**AGENDA
PUBLIC MEETING**

**TOWNSHIP OF EDWARDSBURGH CARDINAL
NOTICE OF PUBLIC MEETING CONCERNING
PROPOSED ZONING BY-LAW AMENDMENT**

**Richard Van Veldheusen o/b Laura Leeder
Part of Lot 8, Concession 1
County Road 2**

RE: COUNTY ROAD 2 - LEEDER ZONING BY-LAW AMENDMENT

Cardinal Updated Site Plan 11.19.21 001.jpg
464K

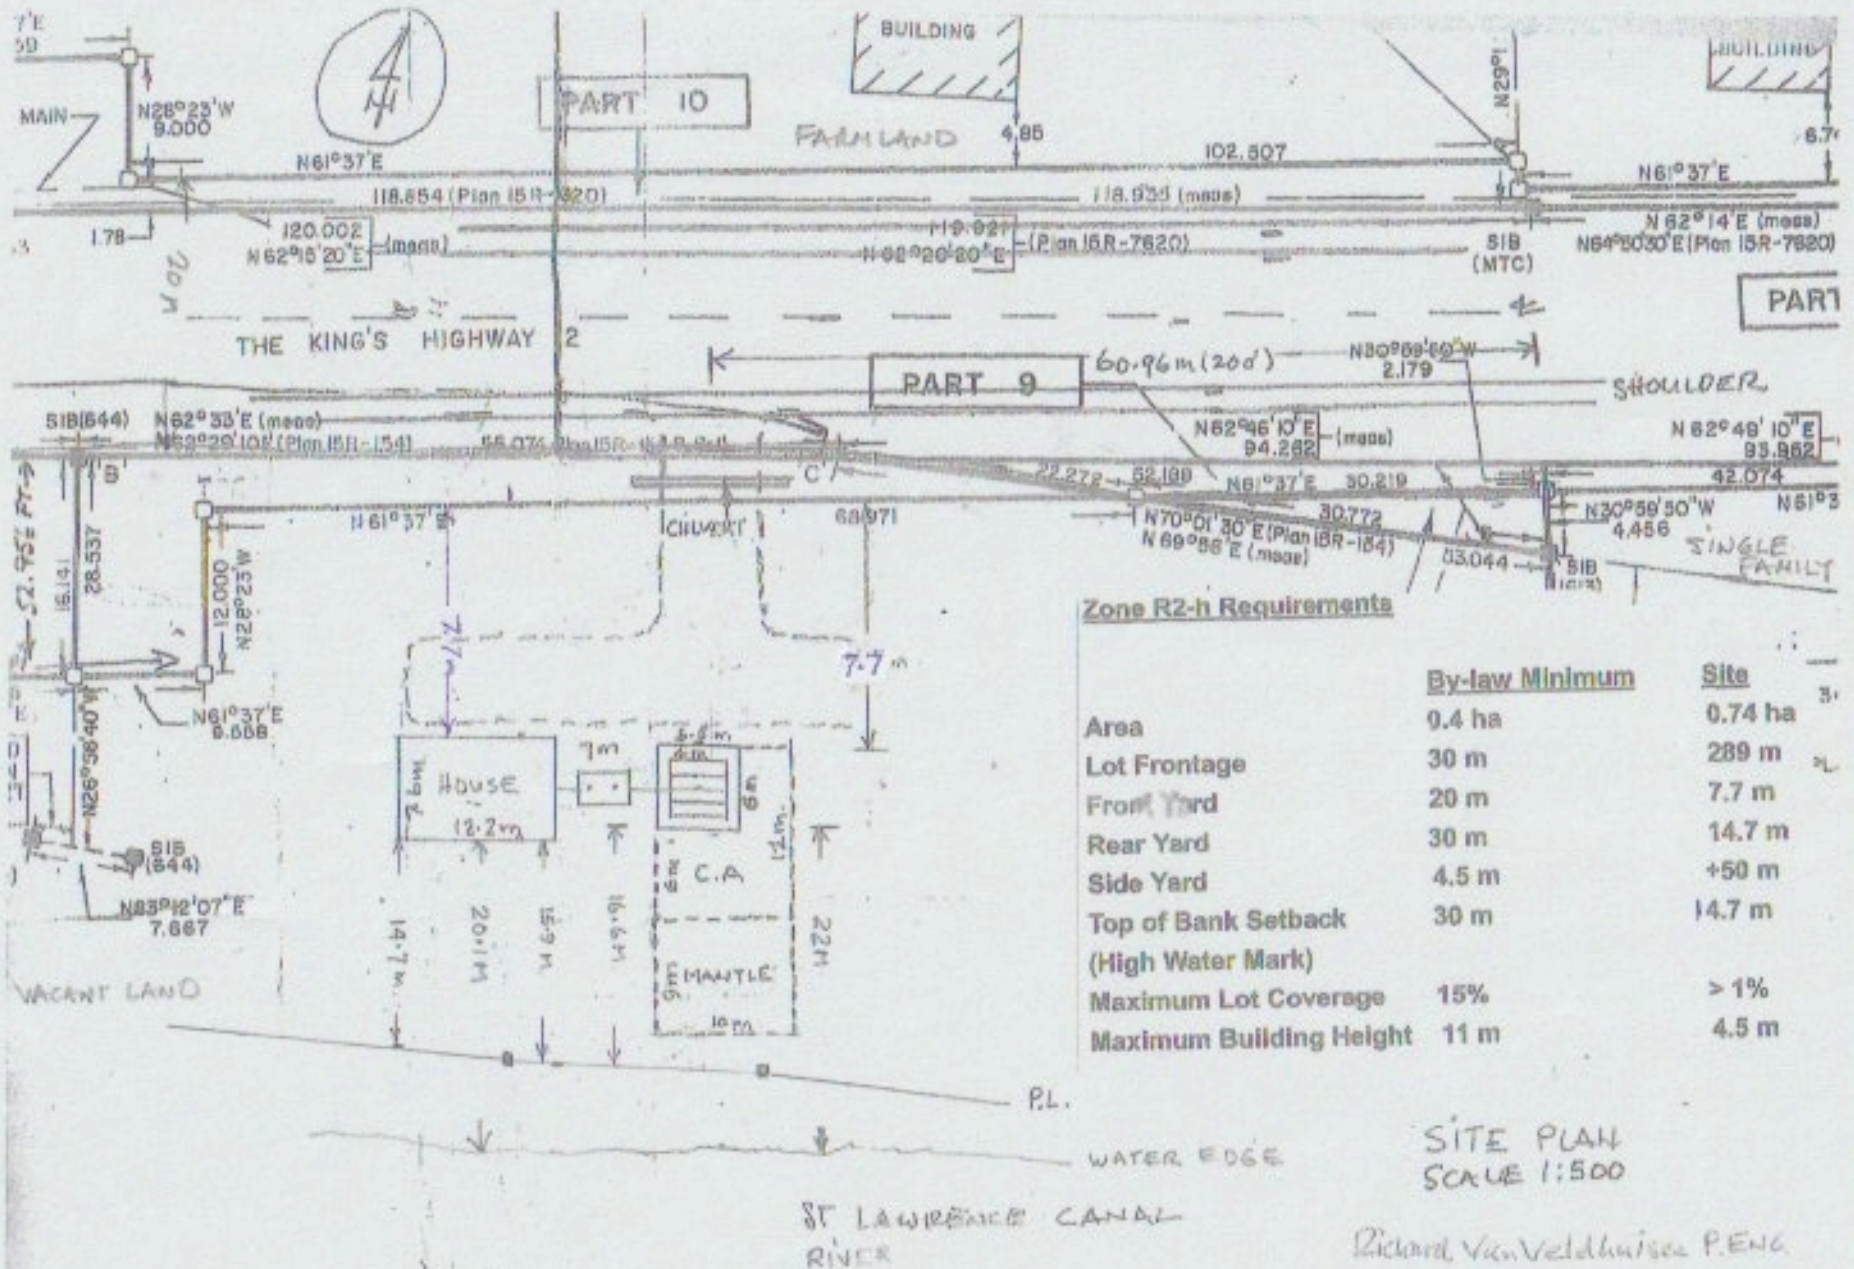
Thank you for the opportunity to comment on this rezoning request. It is understood the application is seeking a 7.7 m front yard setback to allow construction of a residential dwelling. On behalf of the Director of Public works, the Counties would respectfully request that the dwelling be moved back 0.8-1 m further from the road allowance. The rationale for this is that if the County Road is widened to its anticipated maximum of 30.5 m, a 6 m clear zone is required between the guard rails/edge of allowance and any structure. This would not be met at the proposed setback. As such, allowing the dwelling in the proposed location could impede road work in the future.

PARTIAL SITE PLAN
PLAN OF SURVEY
PART OF LOT 8
CONCESSION 1
GEOGRAPHIC TOWNSHIP OF EDWARDSBURGH
TOWNSHIP OF
EDWARDSBURGH - CARDINAL
COUNTY OF GRENVILLE

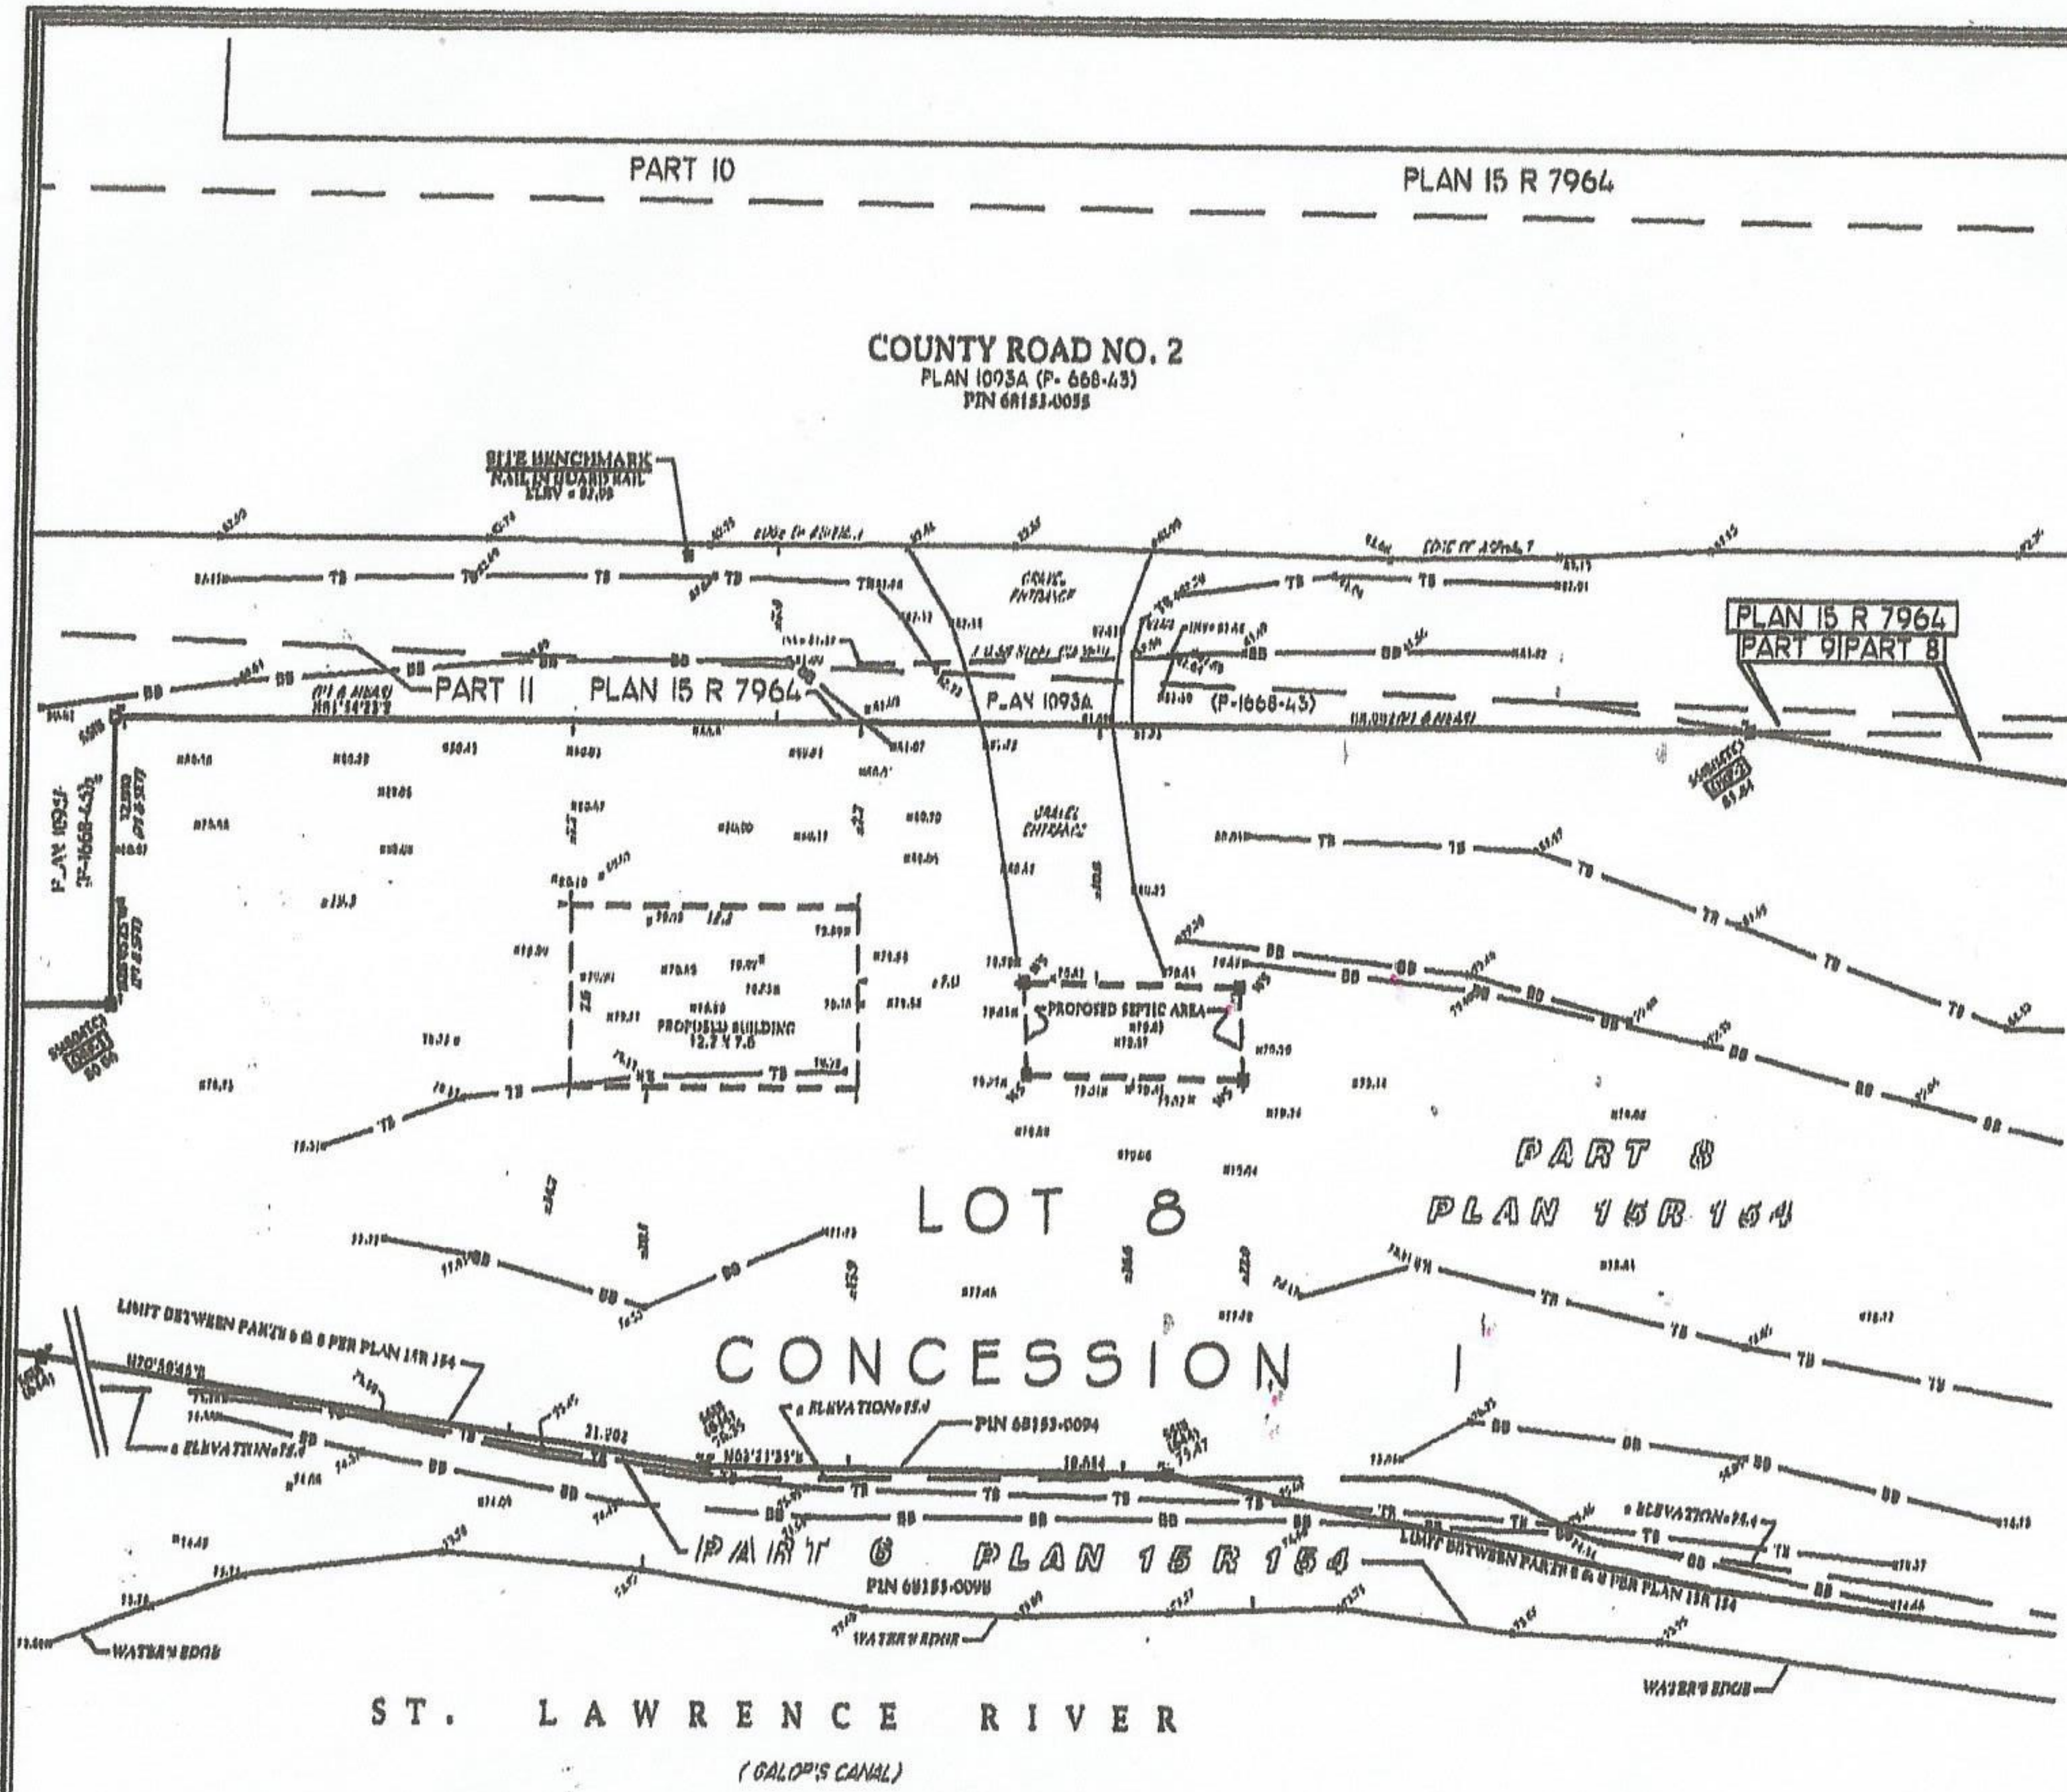
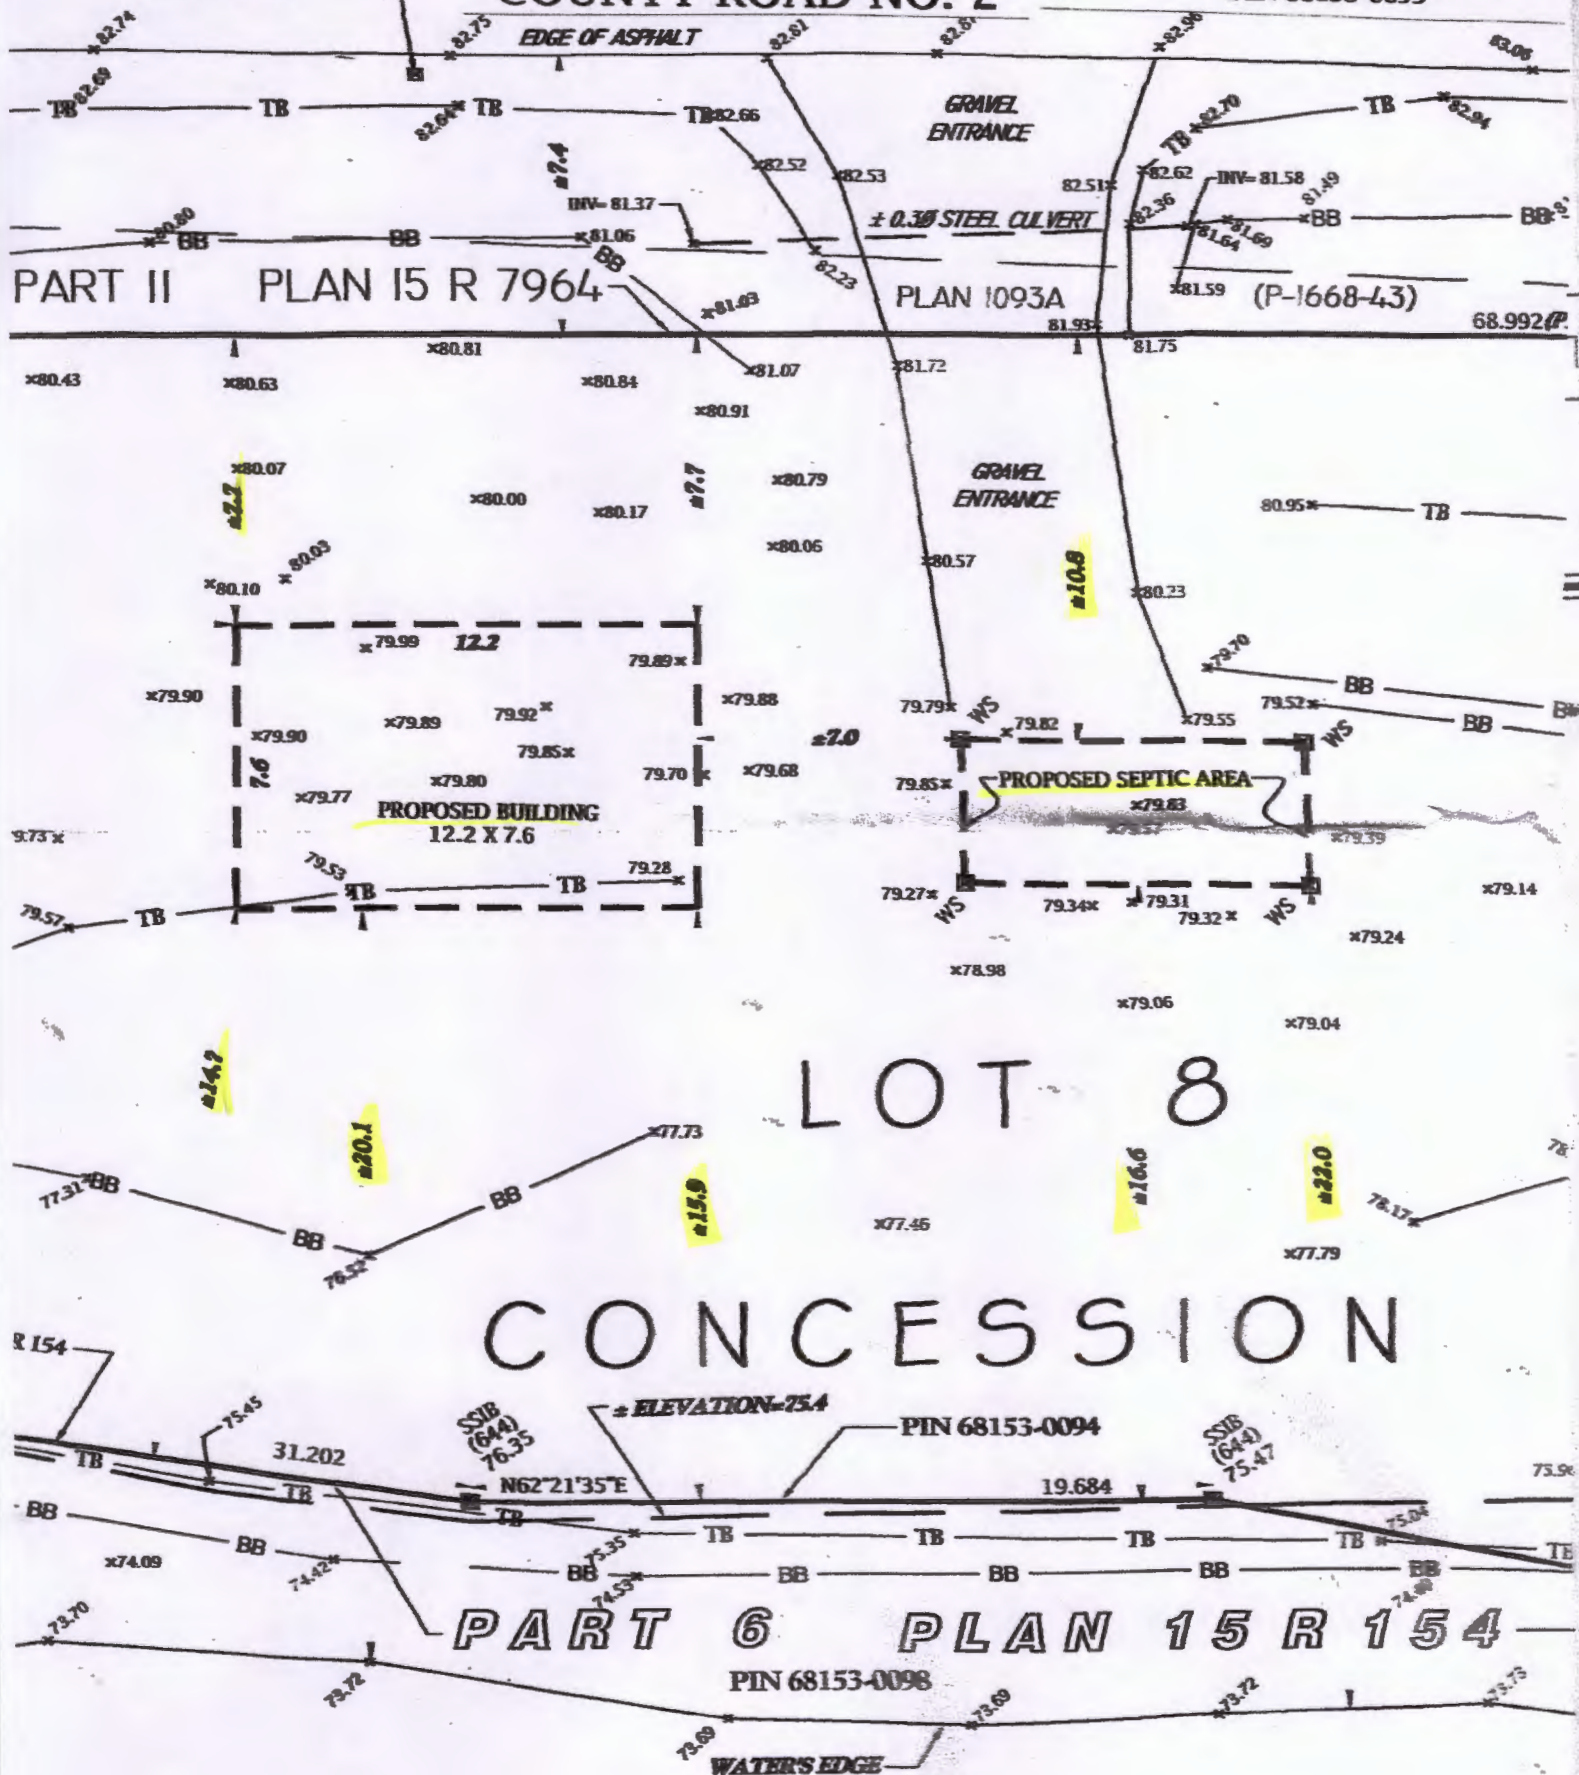
1. The EIS requires a figure that illustrates the following:
 - a. The area on the property that is to be cleared of natural vegetation for construction of the residence (i.e., the building envelope). No site disturbance should take place outside this area, and natural vegetation should remain along the shoreline as recommended by the EIS.

- b. The figure should clearly show measurable setbacks to natural heritage features, riparian buffers where vegetation is to be retained or improved, and distances to any other features to be retained/protected. Riparian buffers and setback widths must be of appropriate width to protect the natural heritage features identified on site and/or those with the potential to be on site.
